**R22 SERVICE BULLETIN SB-114**

**SUBJECT:** D602-3 Time Delay Assembly

**EFFECTIVITY:** D602-3 Time Delay Assemblies Lots 14 thru 21. Affected parts were originally installed on R22 Helicopters S/N 4754 thru 4787. Affected parts were also included in KI-242 Time Delay Installation Kits shipped from January to June 2018 (for compliance with R22 SB-113A).

**FIGURE 1**

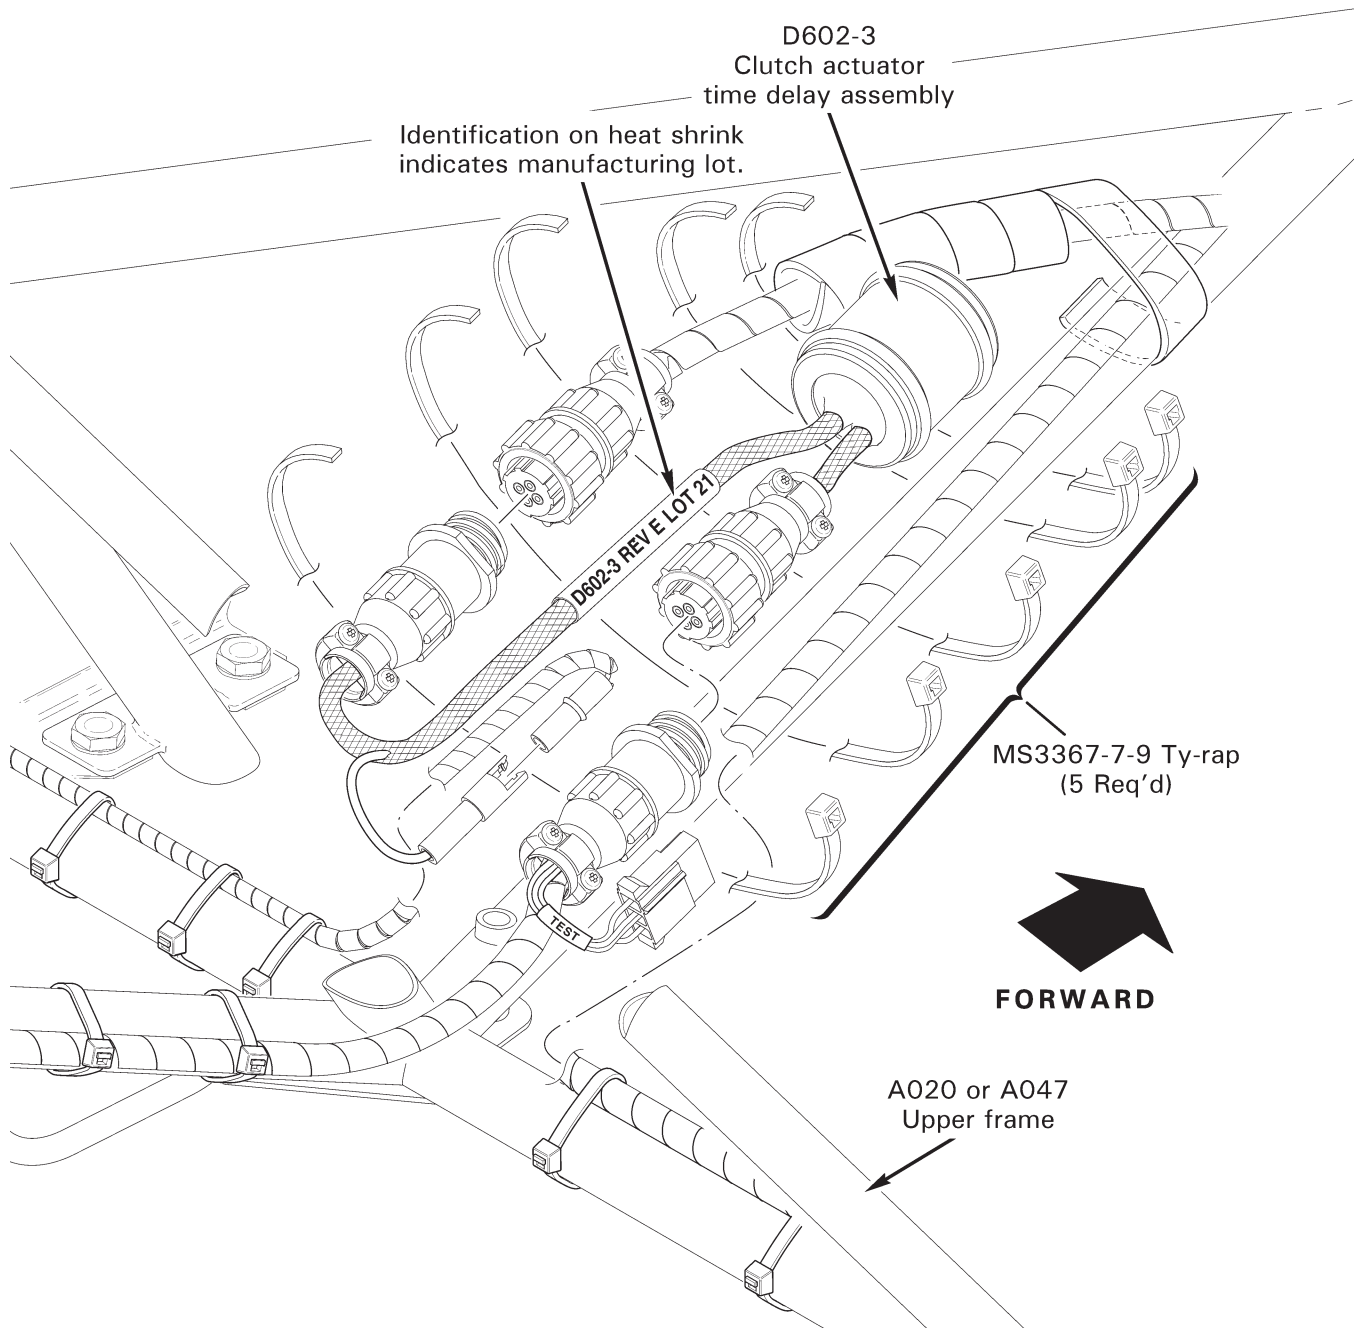
1. Refer to Figure 1. Determine Lot number of installed D602-3 time delay assembly. (Cut ty-raps as required to access identification marking.) If Lot number is not 14 thru 21 the time delay is unaffected; replace cut ty-raps and proceed to step 3.
2. If Lot number is 14 thru 21, or if Lot number cannot be determined, install an unaffected time delay per KI-242 instructions.
3. Make appropriate maintenance record entries.
